Loxahatchee River District Lift Station Remote Telemetry Panels

Addendum Number 3

April 14, 2022

E-3

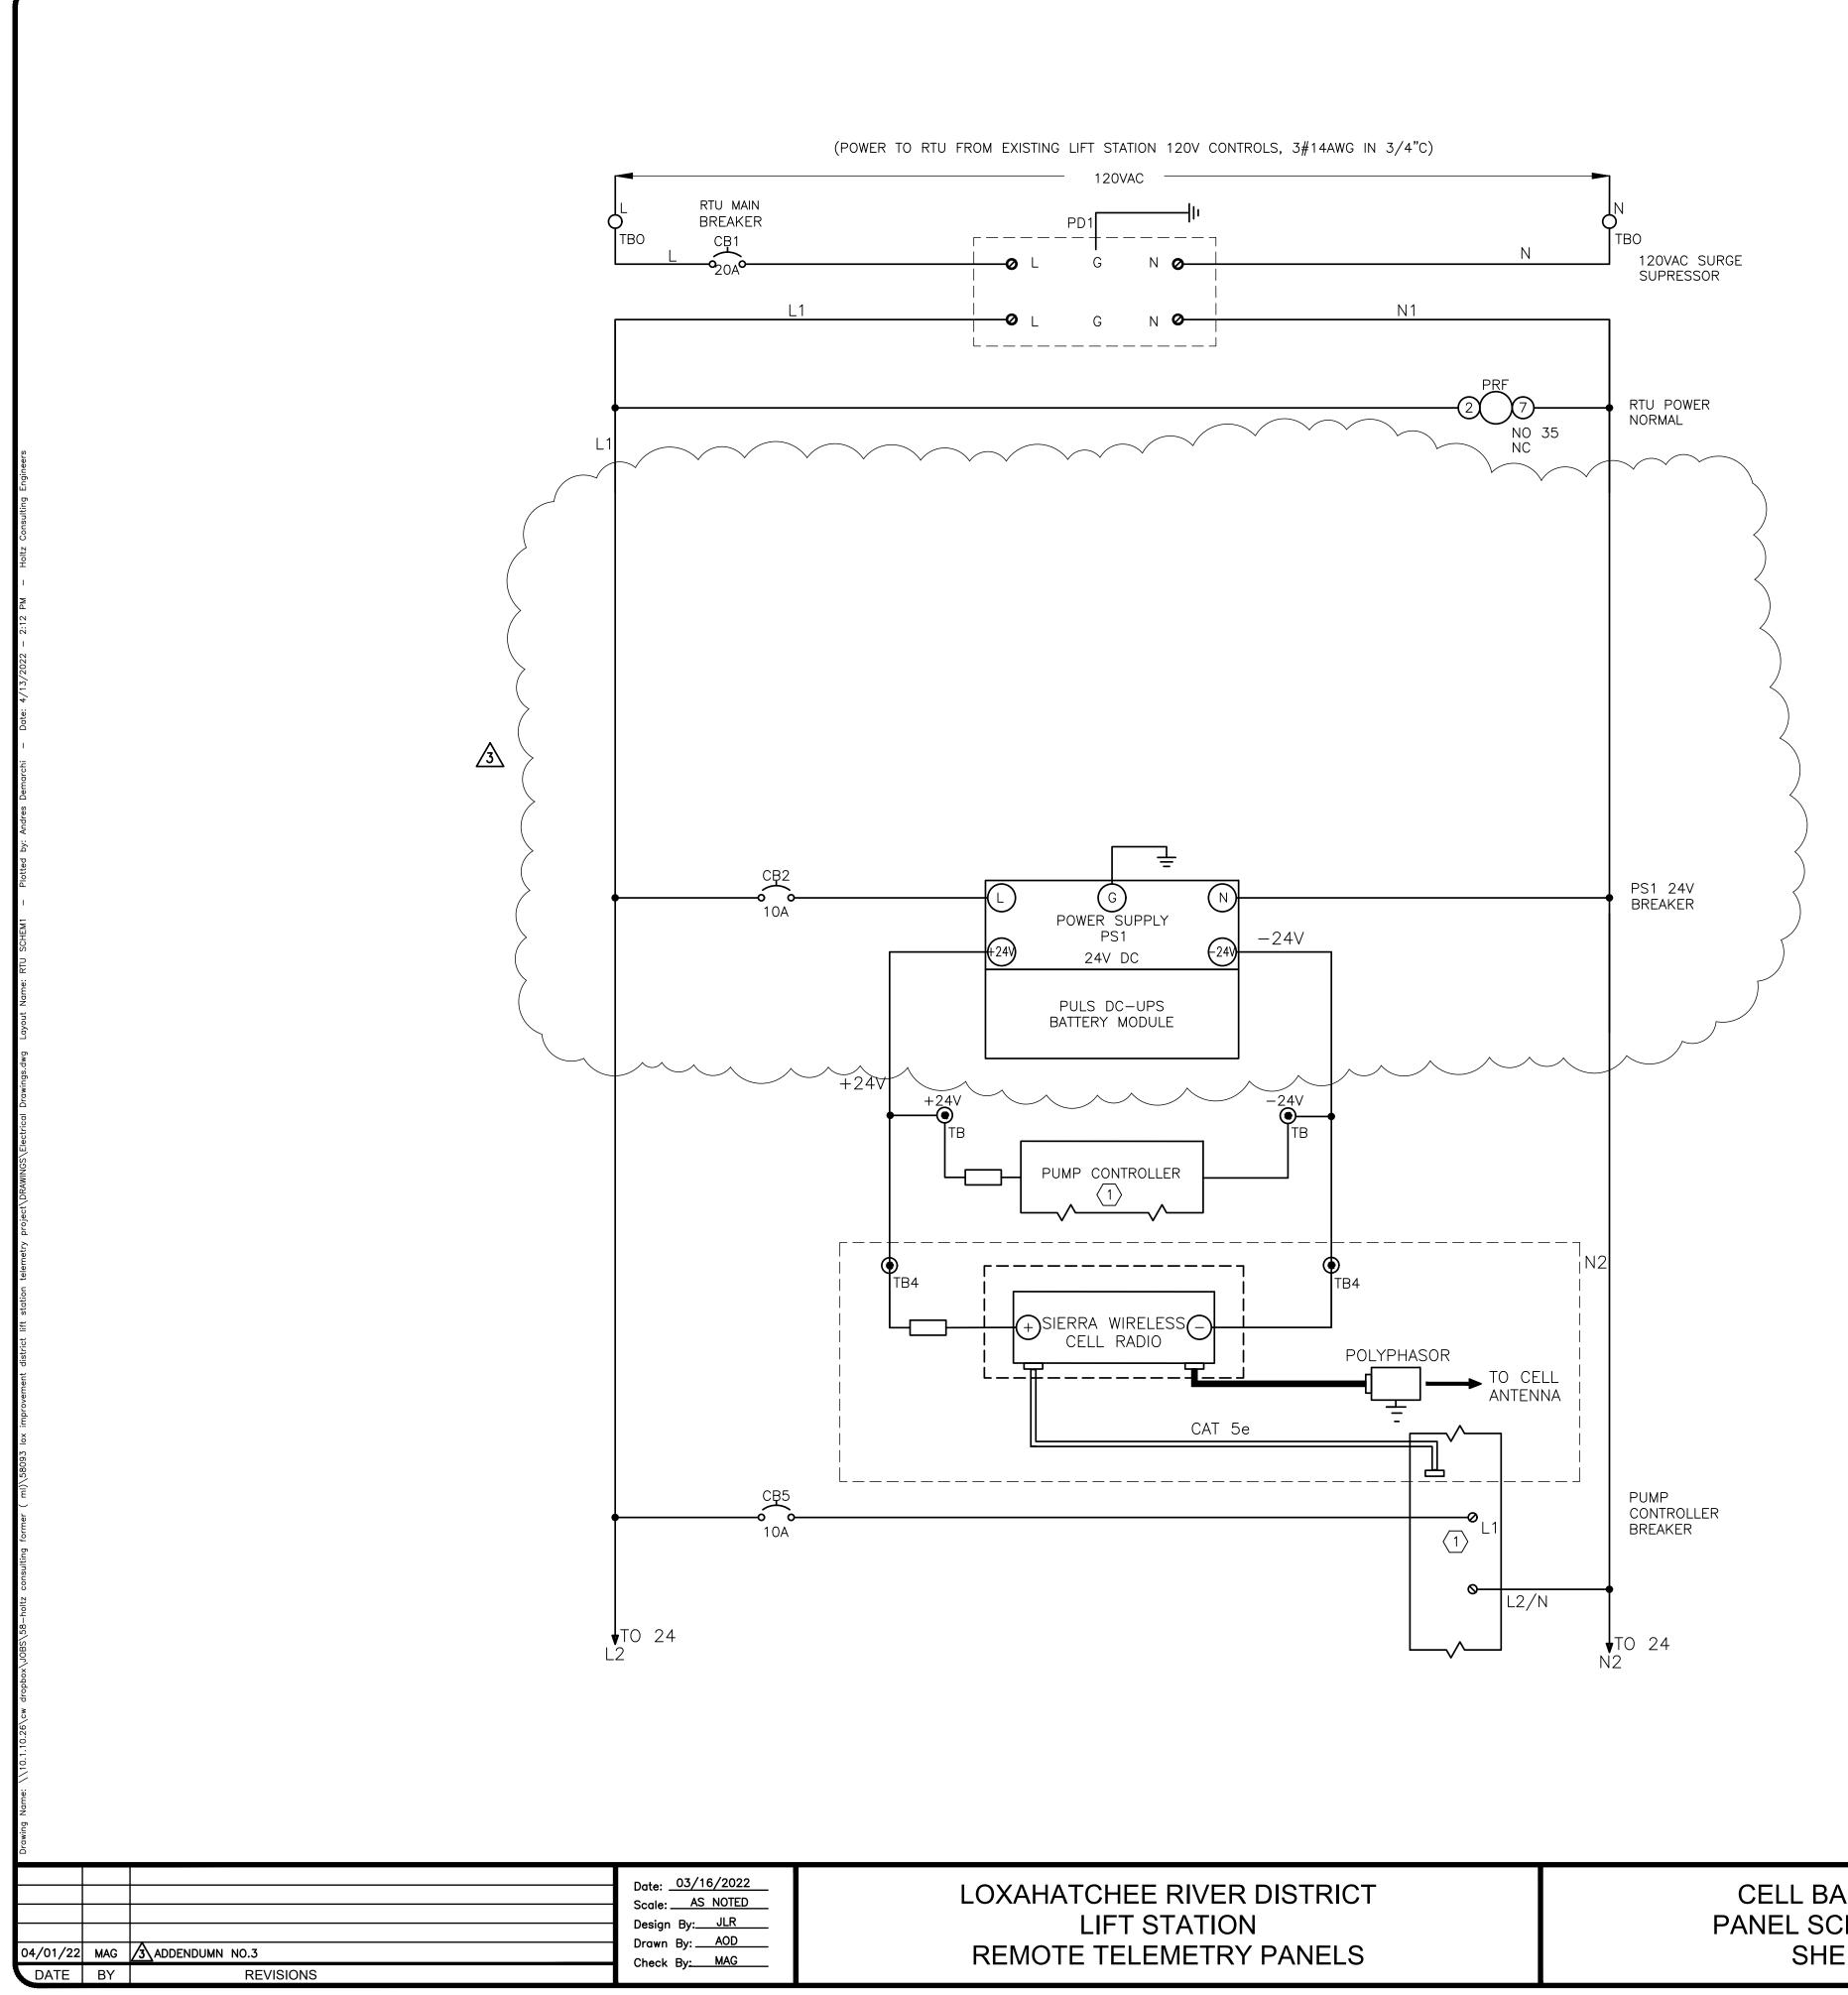
1. PROVIDE RTU WITH SEL OR XYLEM PUMP CONTROLLER AND CELL BASED RADIO.

1 PUMP CONTROLLER SHALL BE AN SEL TRIPLEX PUMP CONTROLLER, OR XYLEM MULTISMART TRIPLEX PUMP CONTROLLER, NO EQUAL.
